LIST OF APPENDICES

Drainage proposal accepted under previous application No. A/NE-TK/678

Proposed Temporary Place of Recreation, Sports or Culture (Hobby Farm) with Ancillary Facilities and Canteen for a Period of 5 Years and Partial Filling of Land Various Lots in D.D. 17 and Adjoining Government Land, Ting Kok Road, Tai Po

(Application No. A/NE-TK/678)

<u>Application No. A/NE-TK/678</u> Compliance with approval conditions (h) and (j)

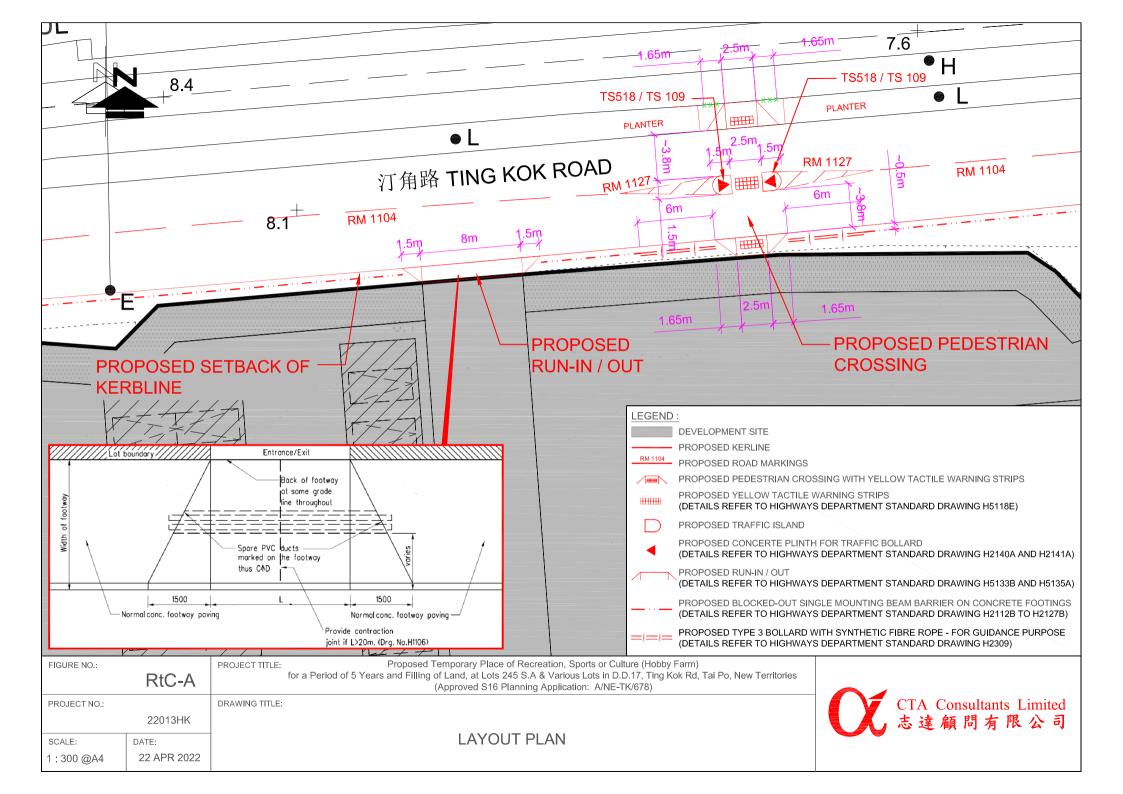
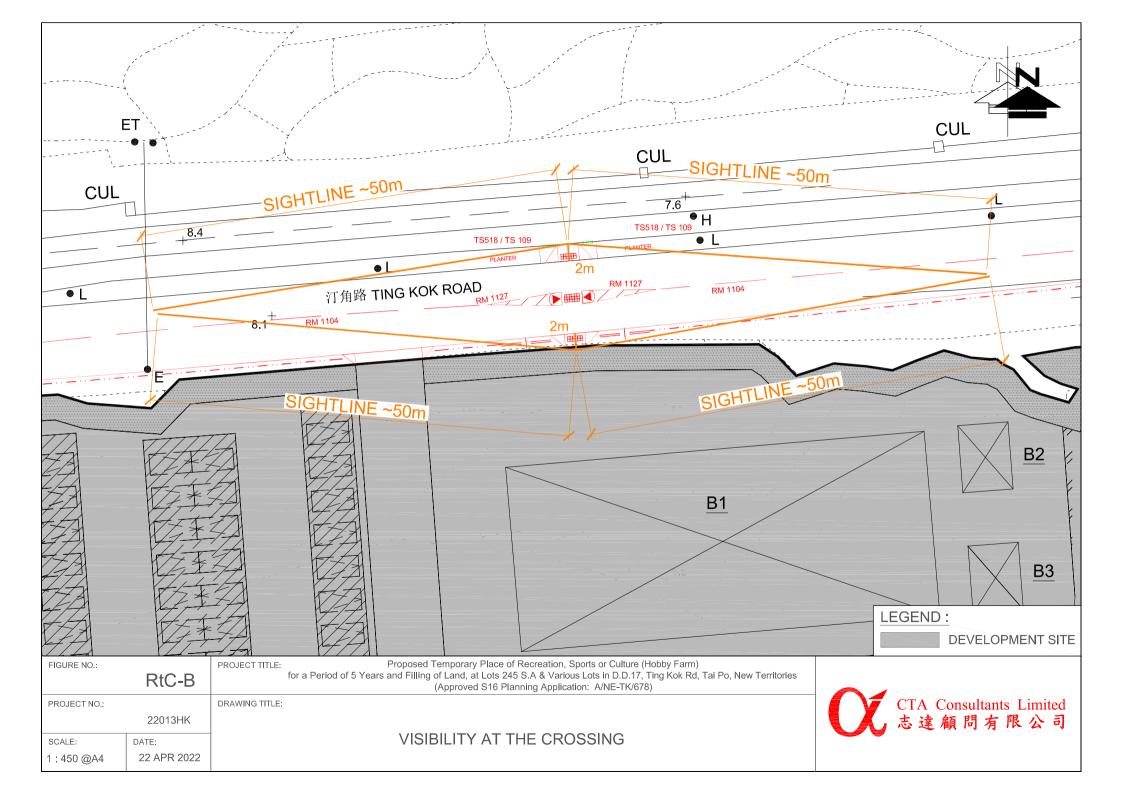
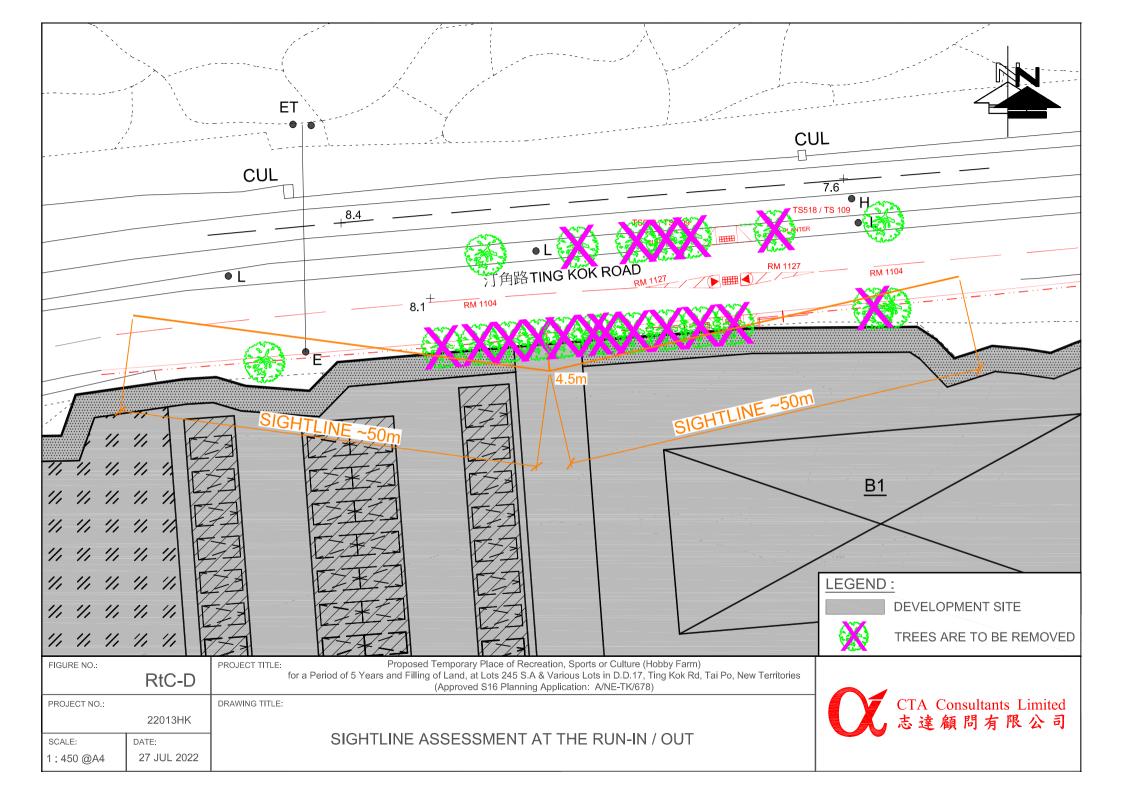
- Roadside tree matter is not under TPDLSO's purview.
- 2. In case that the shrubs/vegetation under our maintenance purview would be affected/to be modified on the proposed existing planter, the project proponent/works department shall reinstate the affected area (including plantings, irrigation system, underground pipes and any other equipment on or below soil surface) at his own cost to the satisfaction of DLCS upon completion of work. After the completion of reinstatement work, the project proponent/works department shall be responsible for establishing the plants on the reinstated areas with 12-month defects liability period if no tree is involved.

- 3. In Figure No. RtC-D, it was noted that roadside trees, which under LCSD's maintenance, would be affected and proposed to be removed as a result of maintaining suitable sightline when a run-in/out and a pedestrian crossing have to be implemented in accordance with the approval conditions (h) and (j) under Section 16 of the Town Planning Ordinance.

- 4. From tree preservation point of view, every possible effort should be made to preserve existing trees on site and minimize any adverse impact on them during the works period. As trees under our maintenance will be affected by the proposed works, the project proponent is reminded to avoid damaging any trees during their course of works. Moreover, if any trees under our maintenance to be felled or transplanted, the project proponent should follow Development Bureau Technical Circulars (Works) (DEVB TCW) No. 4/2020 and duly consider the need of tree removal and consult tree maintenance department (LCSD) to formulate Tree Prescrvation and Removal Proposal (TPRP) at design stage or as soon as practicable. The formal TPRP should be submitted to the respective Tree Works Vetting Panel for vetting and approval.

- 5. We reserve our right to provide further comments when more related information and detailed drawings are available.
